Monte Vista Elementary School Simple Box Daylight Model LEED for New Construction VERSION 4

Simple Box Daylighting Model

APS Monte Vista Elementary School | LEEDv4 Integrative Planning Deliverable | p3

First Floor Opaque Panels

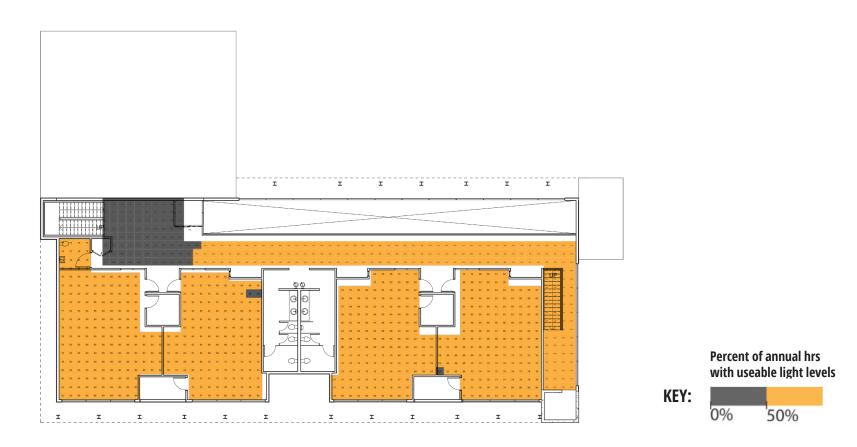
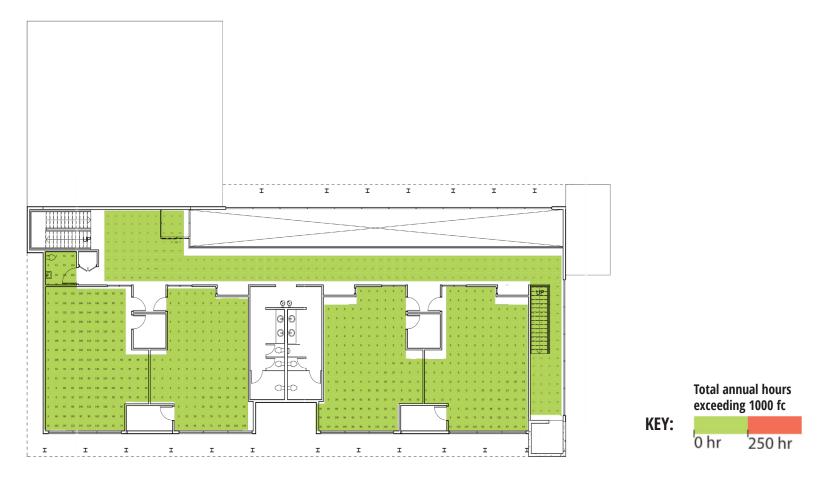
Recommendations

-Provide additional shade at east circulation

-Provide additional shade at east side of north classroom

First Floor 25% Open Panels

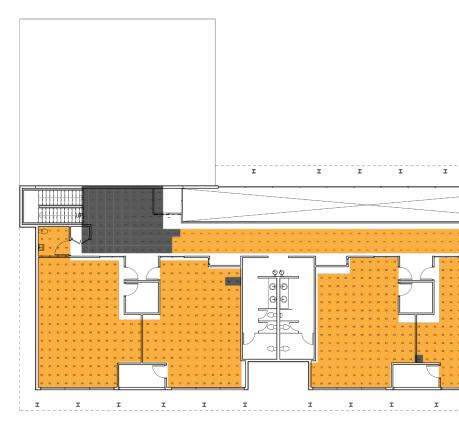
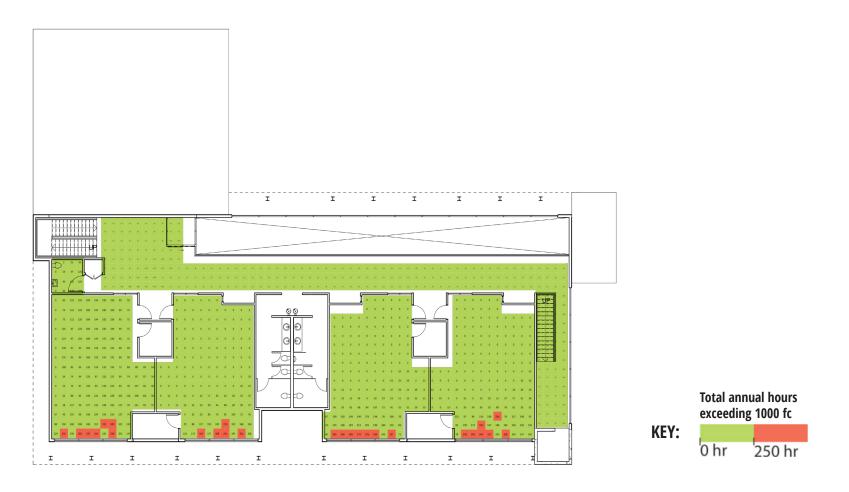
Recommendations

-Provide additional shade at east facade

-Provide additional shade at east side of north classroom

-Additional shading at south glazing

Second Floor 25% Open Panels

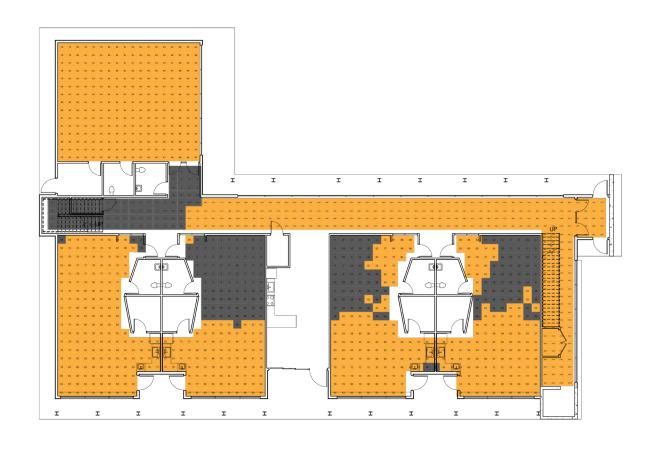
Recommendations

-Scenario is performing well in both metrics

-Clerestory glazing above north classroom may improve circulation light availibility

First Floor 50% Open Panels

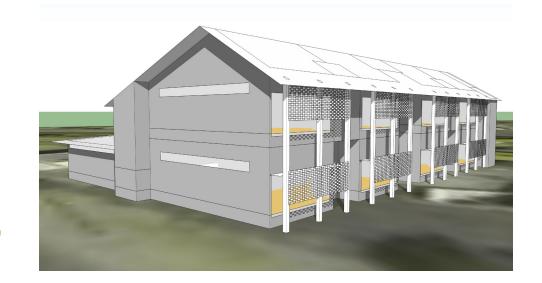
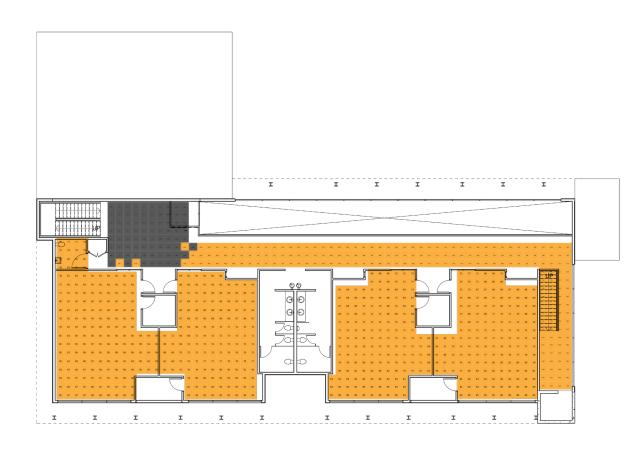
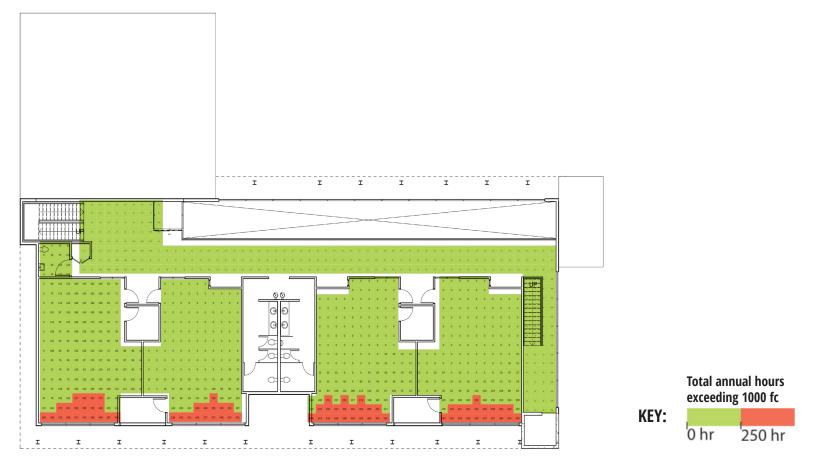
Recommendations

-Provide additional shade at east facade -Provide additional shade at south facade
